Project Amendments  
BLD2021-03082  
APN 037-333-200  
130 Bridgeport Dr.  
Half Moon Bay, CA 94019

## SUMMARY OF CHANGES

November 2, 2023

EAST ELEVATION

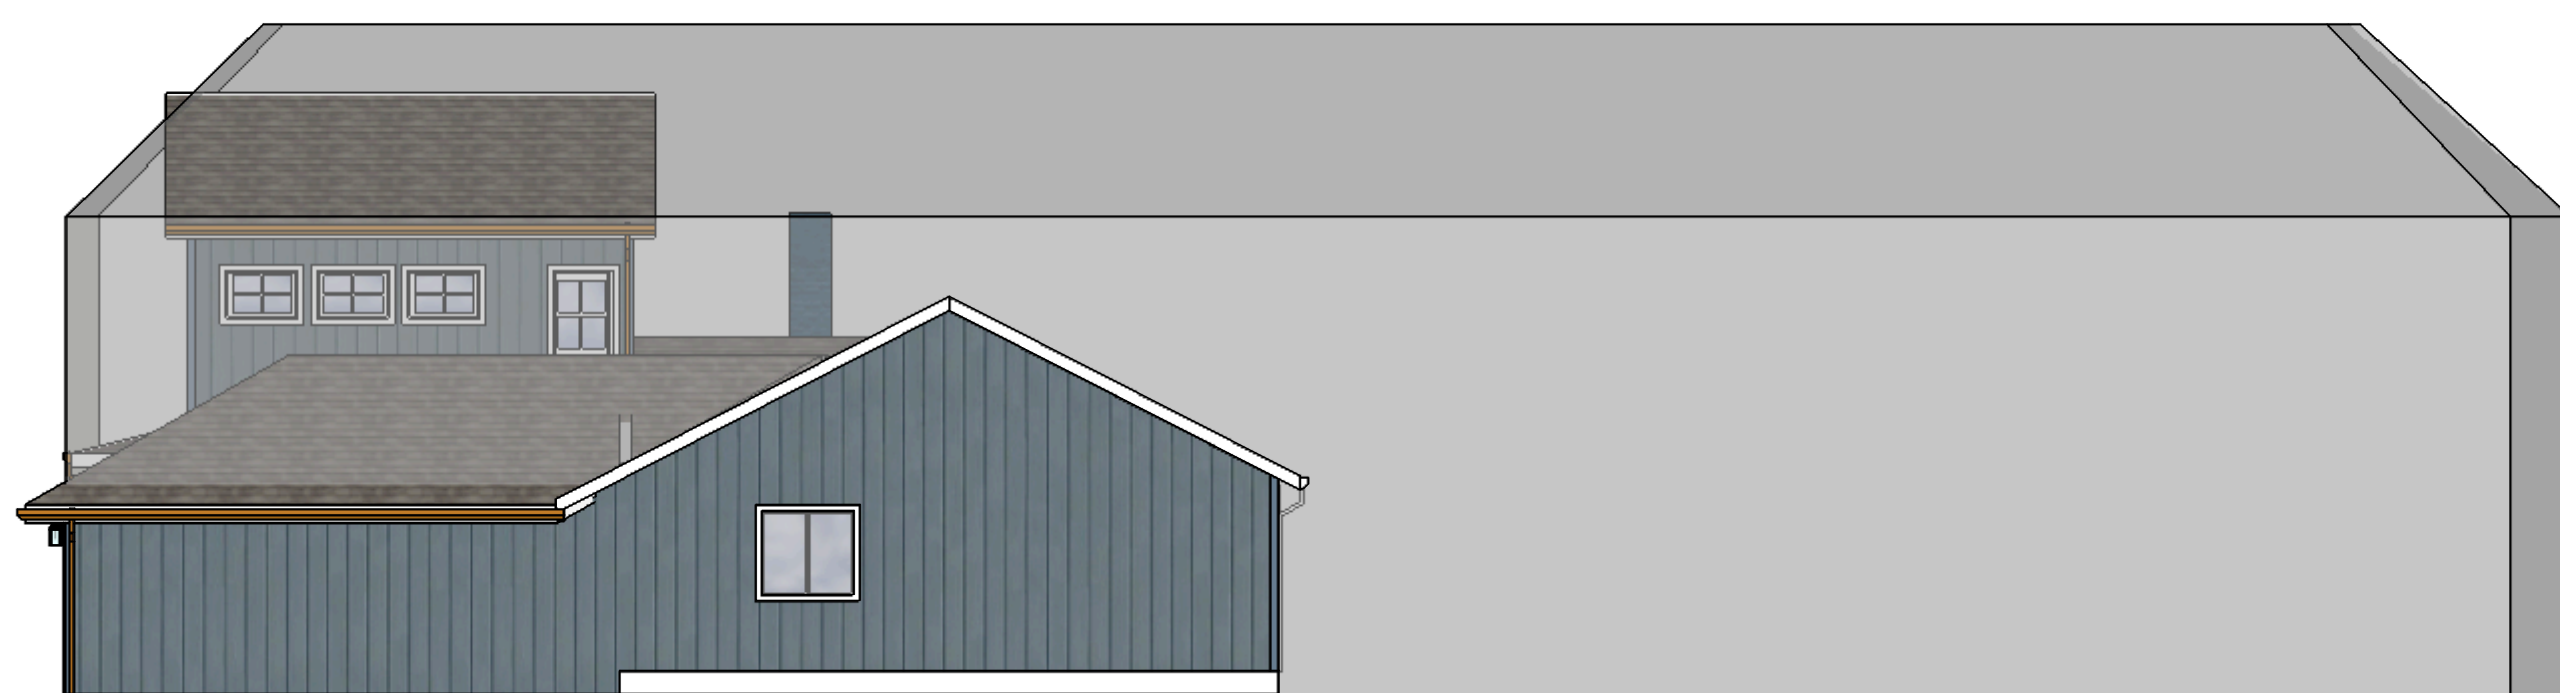
The first change proposed is the building height. The approved Ridge Elevation was 62.5 and the surveyed height is 63.3. The height of the structure is 25'4" and well within the height restrictions for zoning district R-1/S-17. The approved height was 24'1". This architectural change was made to match the drawings provided by the structural engineer. Details are noted in the Plans on pages G0.01 under Site Data, A3.01 Proposed Exterior Elevation – East and North, A3.02 Proposed Exterior Elevation – West and South, A6.01 Proposed Building Section, and A8.02 Daylight Plane Study – Elevations. Please note that the approved Daylight Plane Study showed the eaves of the front of the second story on the new addition extending 6" outside of the daylight plane (there are no changes to the first floor).

### 4 COLOR/ MATERIAL BOARD

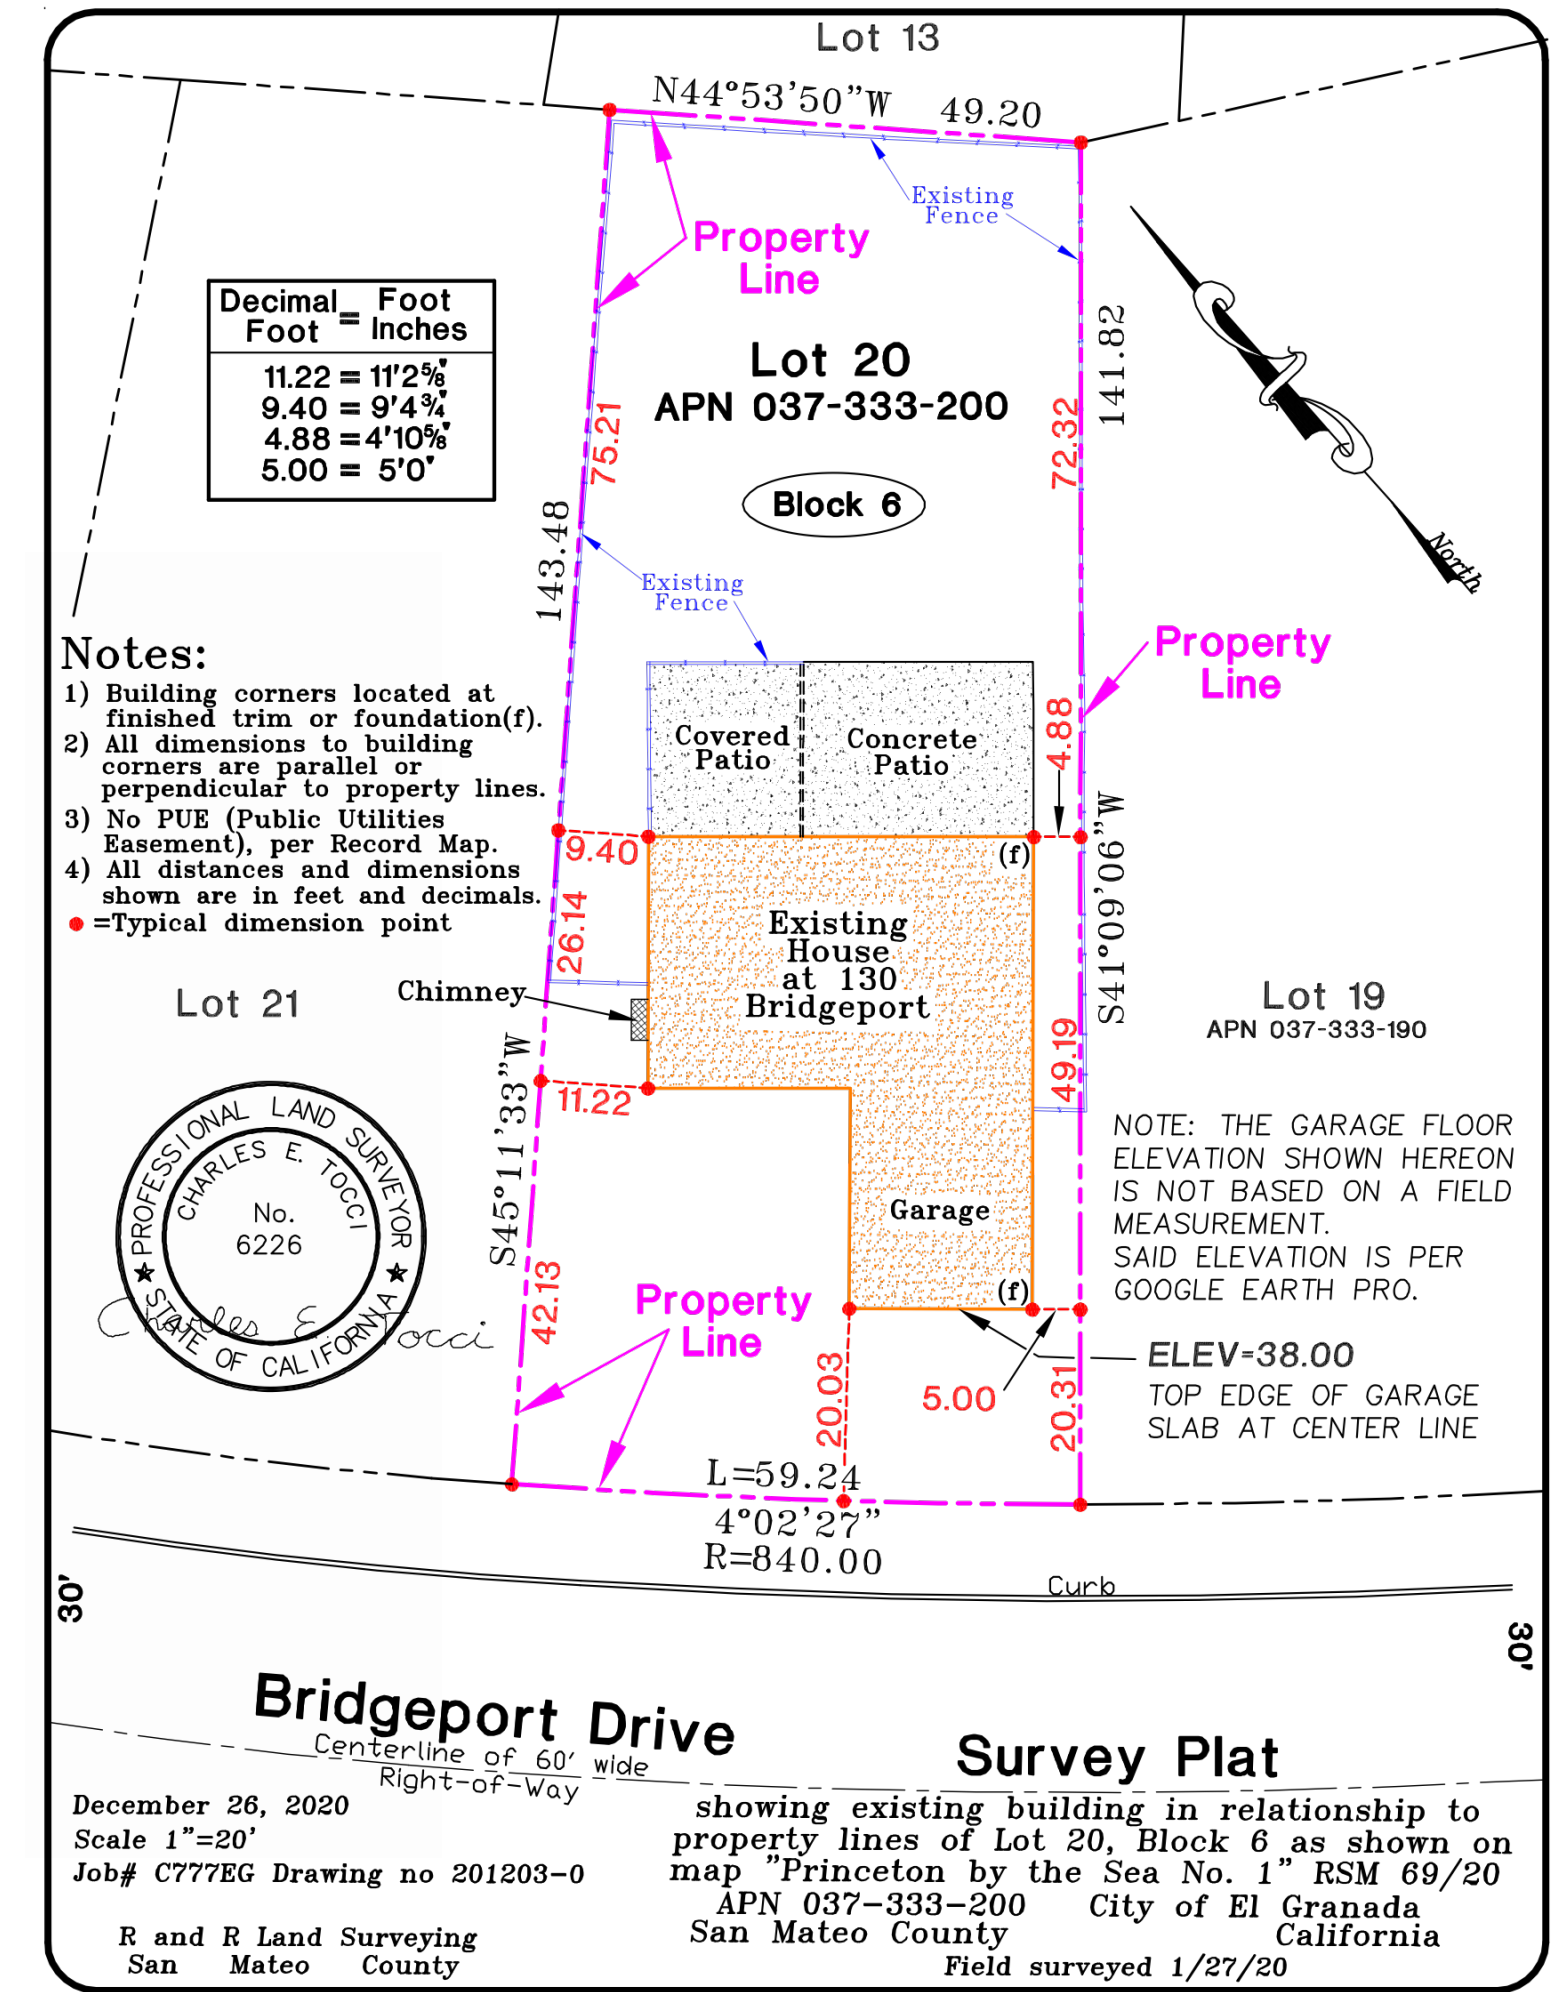
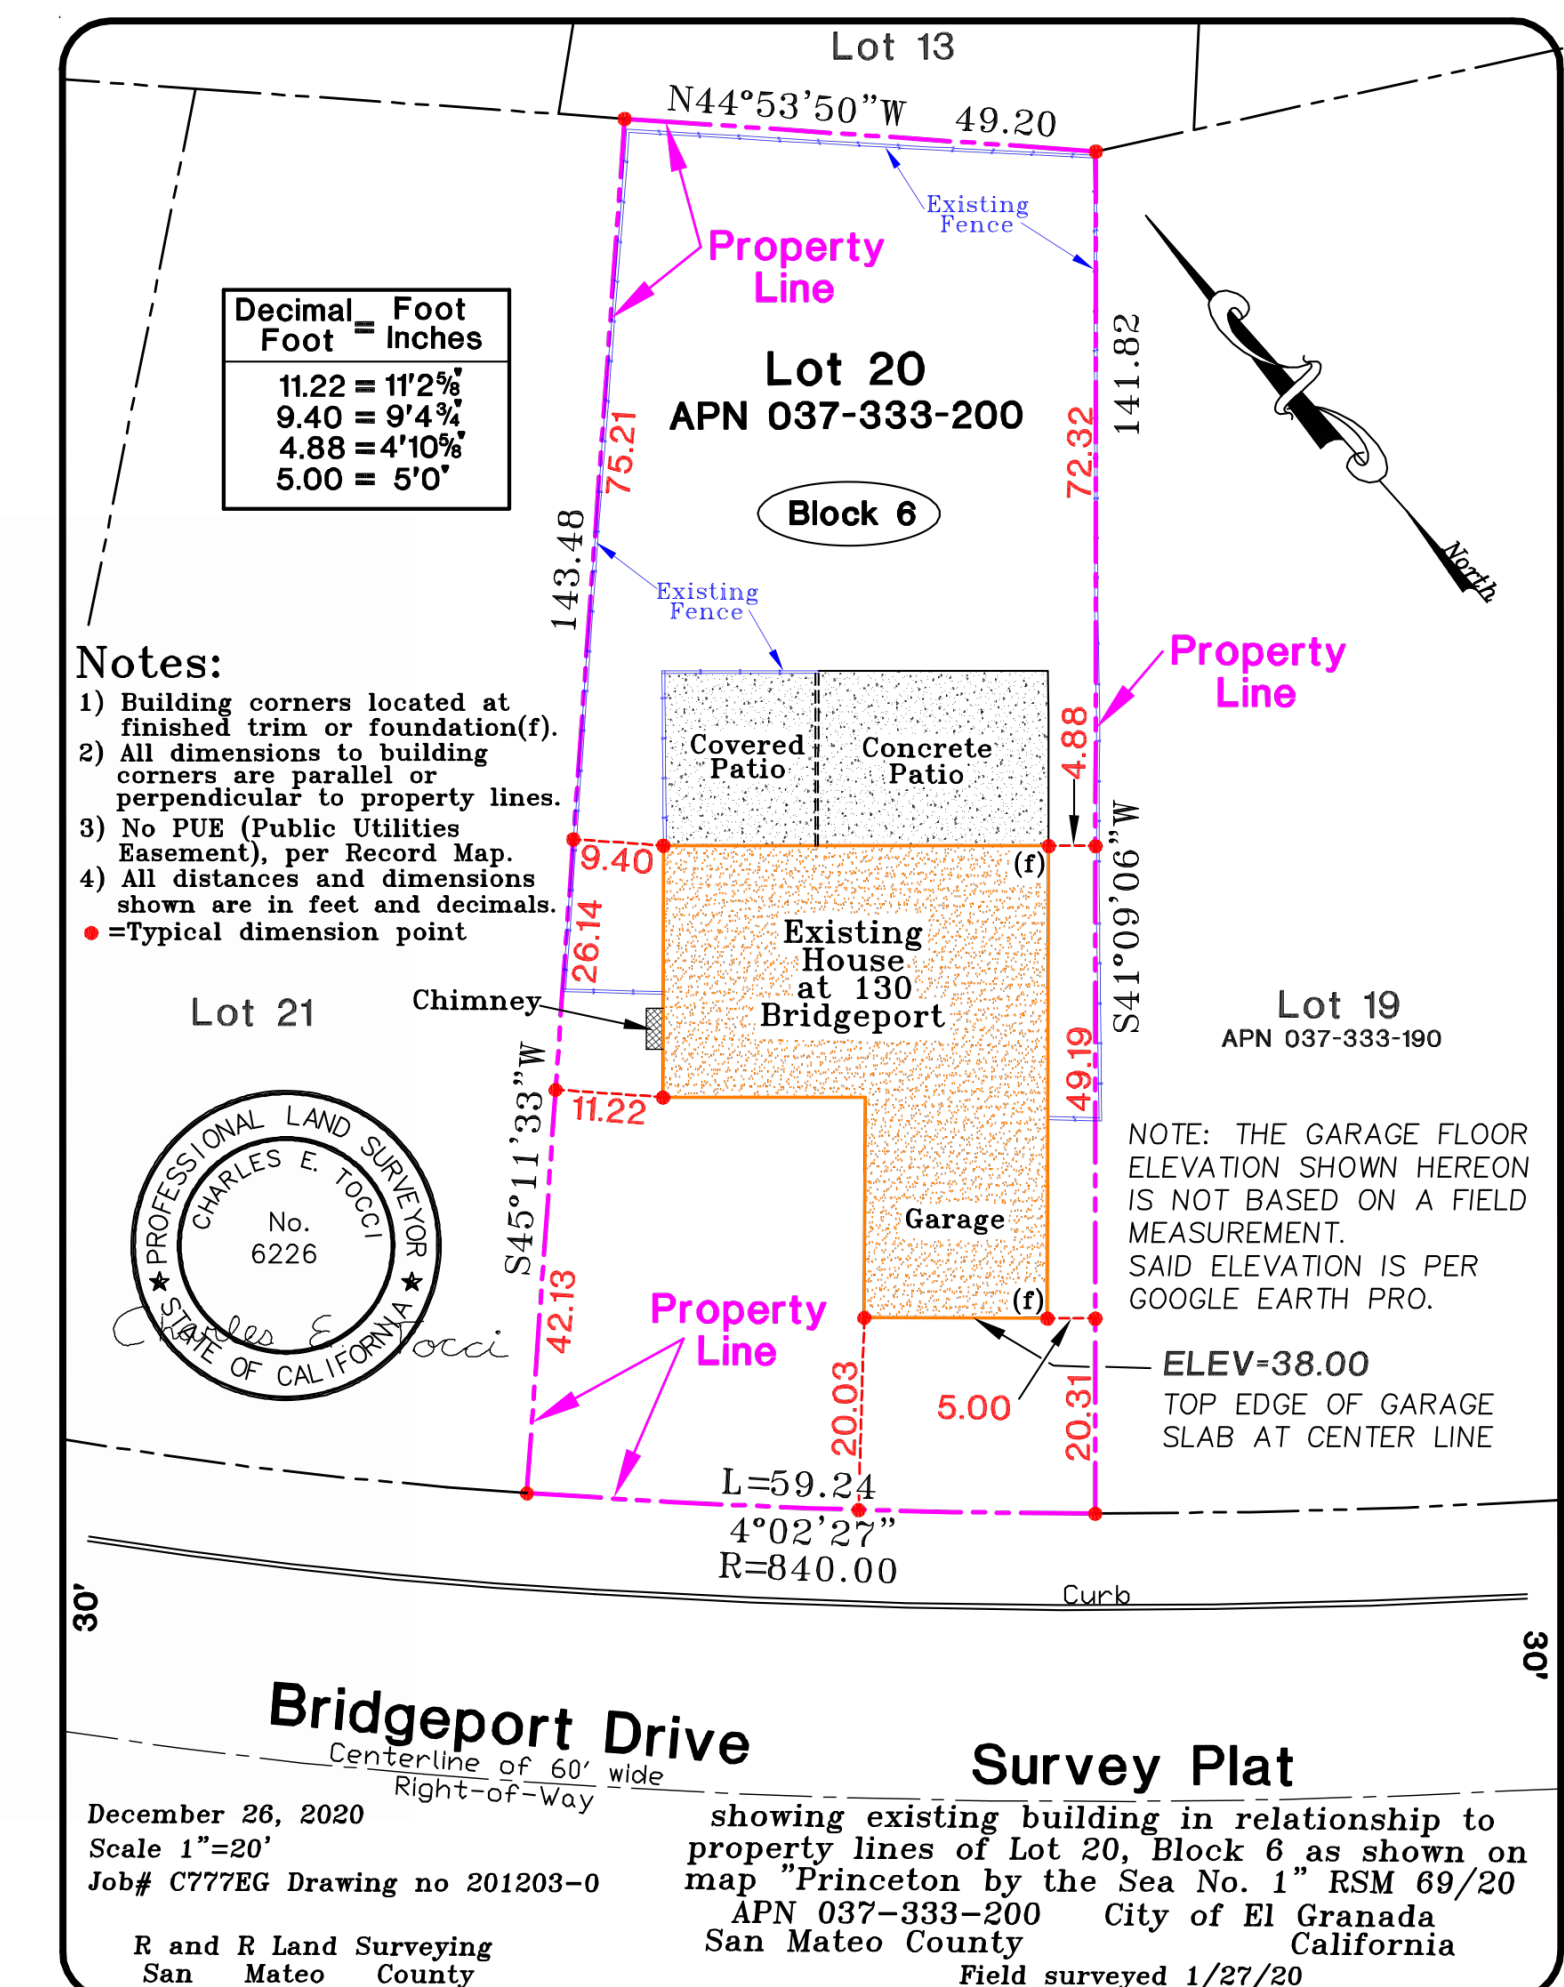
The second proposed change is our paint plan, roof color, and gutters. These changes are noted on pages A1.01, A3.02, A8.02 Color/Material Board and Statement of Compliance – DR STDS. The approved color was Newburyport Blue for the siding and Extra White for the trim and fascia. The colors we chose are Benjamin Moore Blue Note for the siding, which is grayer than Newburyport Blue but is very similar. For the trim and fascia, we chose Benjamin Moore Classic Gray, which is considered an off-white, as you can see in the Color/Material Board on page A8.02. After design consultation and research, we chose an off-white for the trim because a true white would be too bright in contrast to the blue siding.

We also propose to paint the garage door and chimney in Blue Note to match the siding, as we have seen on many homes in our neighborhood and throughout the Coast.

For the roof, it was cost effective to replace the roof on the existing house when the new roof was installed so we removed the beige shingles that were included in the approved plans and went with dark gray shingles for the entire home.

Lastly, after consultation with our gutter contractor, we chose copper gutters as an aesthetic upgrade and because they will last forever.

- (N) ROOFING - DARK GRAY
- (E) ROOF & (N) ADDITION ROOF MATCH
